SERVICE BULLETIN SB00.24

Machines/Models: SL20

PURPOSE: Add Weight to the Chassis

Figure 1

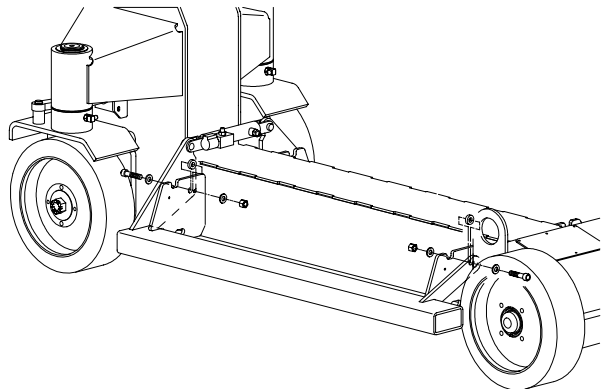
PROCEDURE REQUIRED: Replace the Left Depression Weldment

1. Remove the attaching bolt from the left depression cylinder attachment (retain hardware for reinstallation)(see Figure 1).
2. Remove the attaching hardware from the left depression weldment hinge points (retain for reinstallation).
3. Remove the left depression weldment (see Figure 1).
4. Install the supplied depression weldment.
5. Align the mounting holes and install the hardware removed in step 2.
6. Attach the depression mechanism to the actuation cylinder using hardware removed in step 1.
7. Torque the installed hardware to 65 ft lbs (88 Nm).
8. Perform Pre-Operation and Safety Inspection as instructed in the Operator Manual to ensure proper operation of machine.

KIT INCLUDES: 1 each -101084-000 Depression Weldment
